SUBJECT: D. C. COOK NUCLEAR POWER PLANT, UNITS 1 AND 2  
NRC INSPECTION REPORT 50-315/02-07(DRP); 50-316/02-07(DRP)

Report No: 50-315/02-07(DRP); 50-316/02-07(DRP)

IR 05000315-02-07(DRP), IR 05000316-02-07(DRP), Indiana Michigan Power Company, 06/13-19/2002, D. C. Cook Nuclear Power Plant, Units 1 and 2. Special Inspection.

SIMPLIFIED OFFSITE POWER SOURCES  
 SHEET NO. FSAR FIG. 8.1-2A

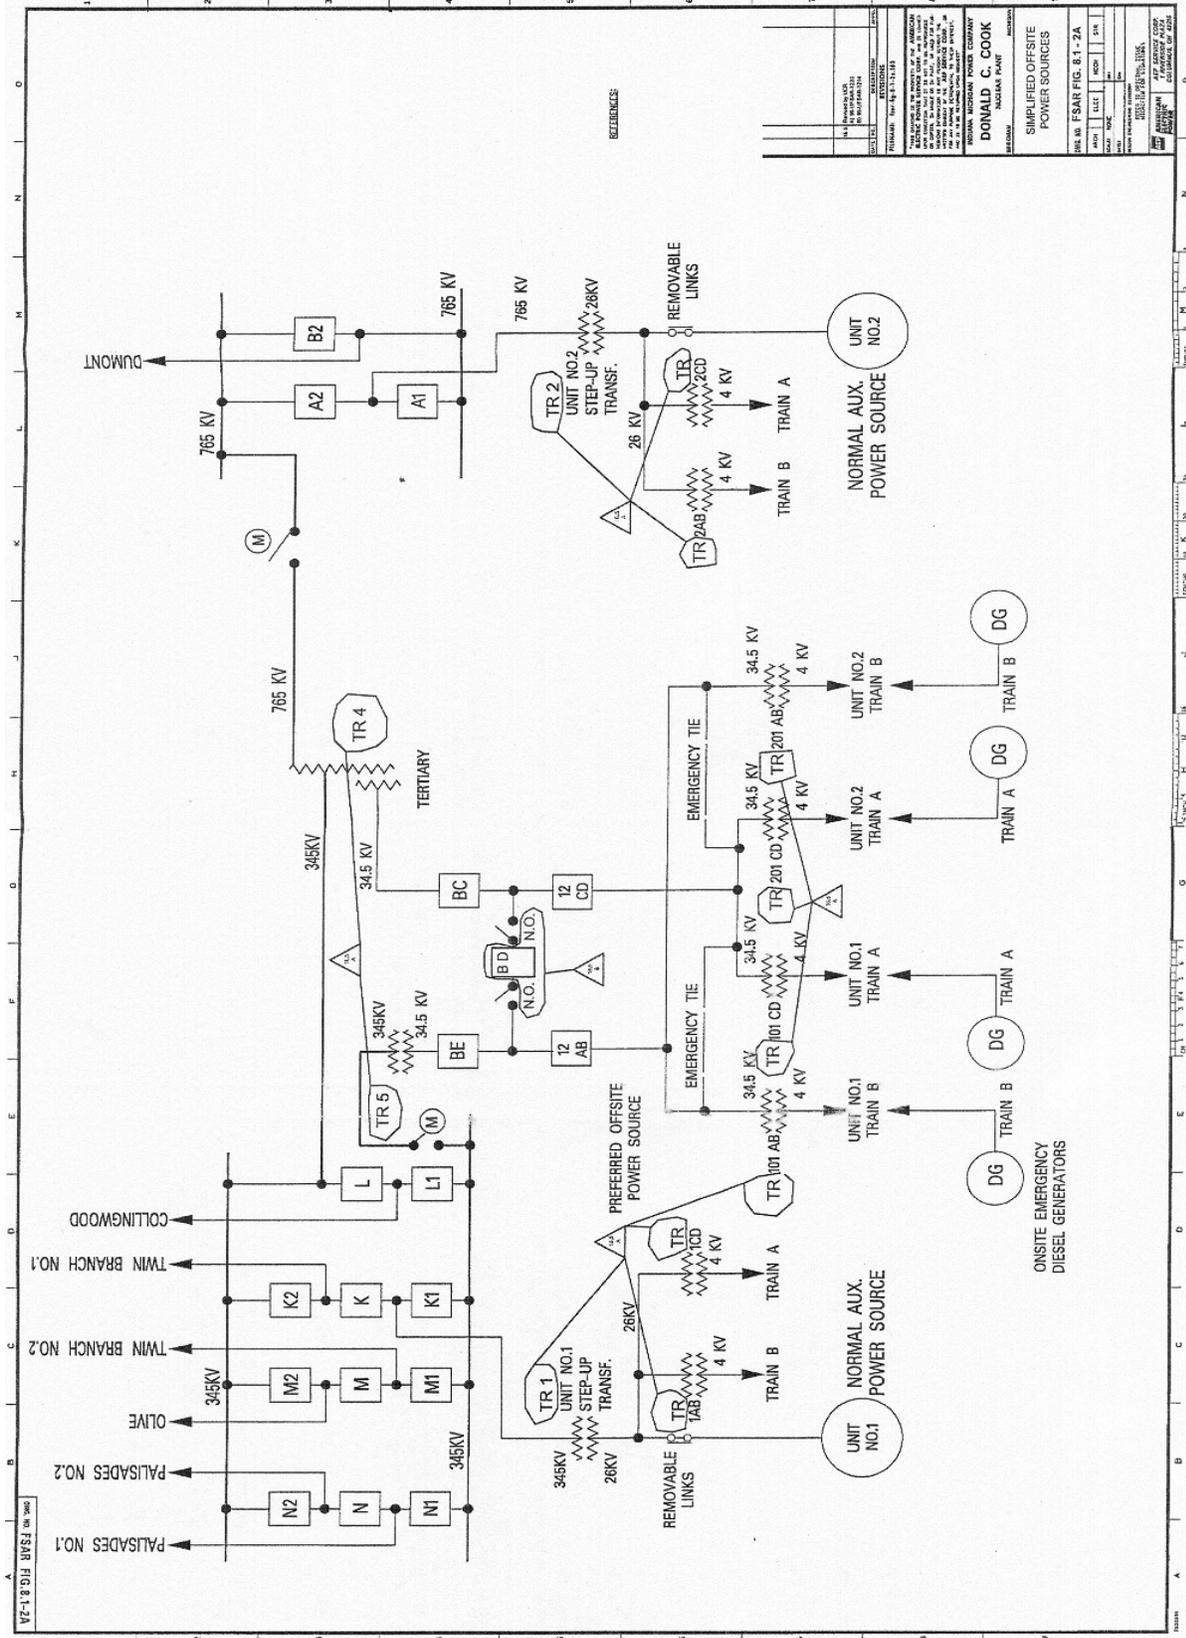
Note: A list of documents reviewed during the inspection is included at the end of the report. Also, Final Safety Analysis Report (FSAR) Figure 8.1-2A, "Simplified Offsite Power Sources, D. C. Cook Nuclear Plant," is attached at the end of the report for reference.
